CITY OF MERCER ISLAND

RE: Request for Information #2 for File No. SUB21-008 – Koneru Short Plat
6610 East Mercer Way, Mercer Island, WA 98040; King County Tax Parcel # 302405-9153

KONERU SHORT PLAT, SUB21-008

May 11, 2022

SITE MAP
SCALE: 1"=40'

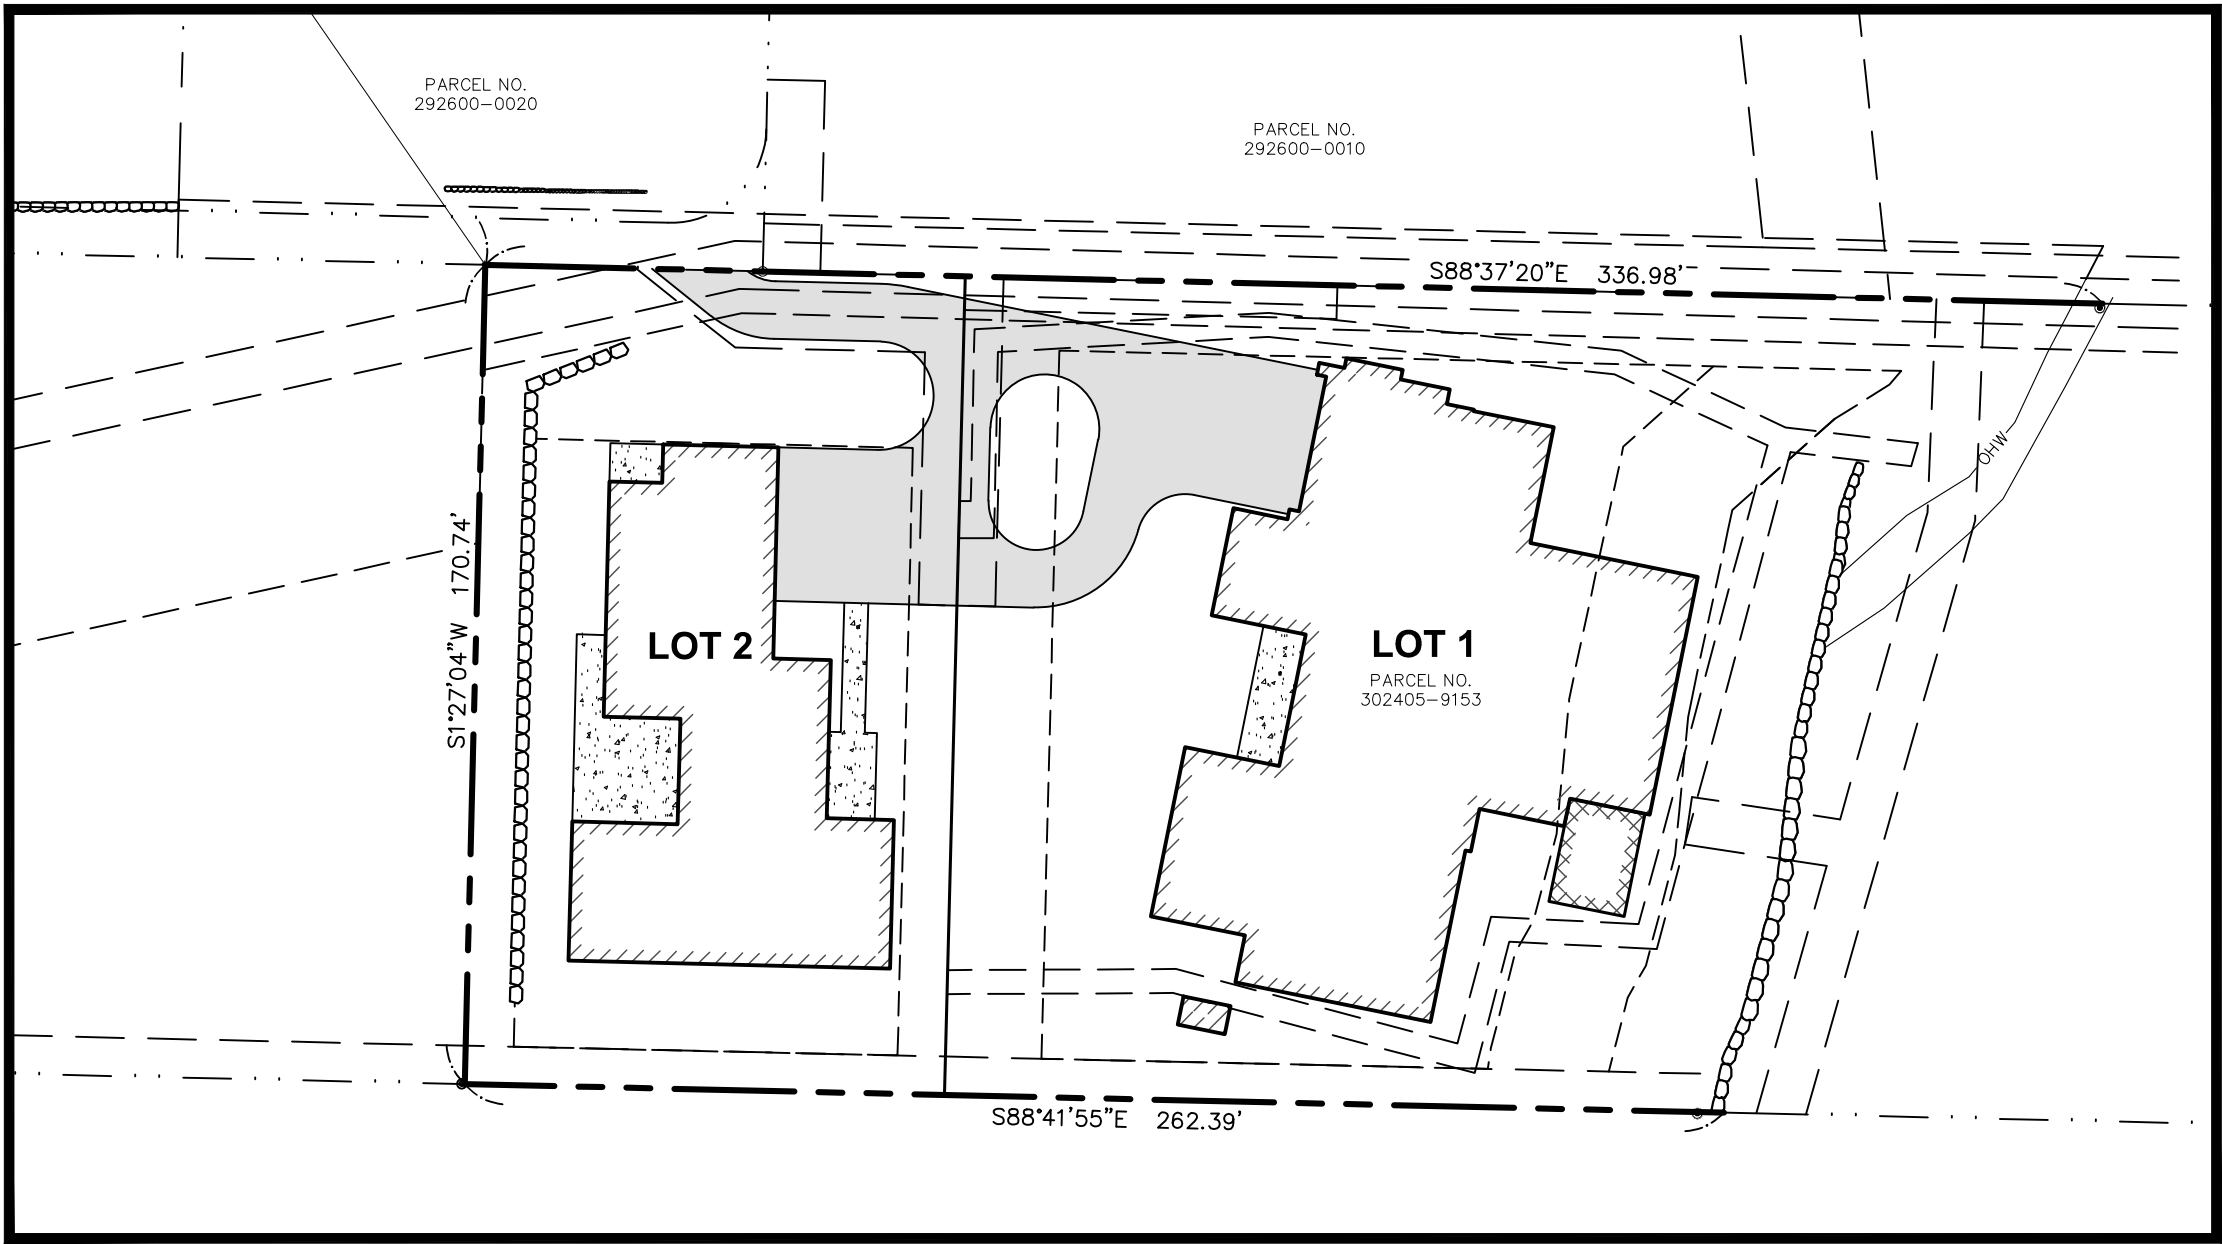
Therefore, we agree with the statement on the cover sheet of the plans. ***“This request does not guarantee that the lots will be suitable for development now or in the future.”***
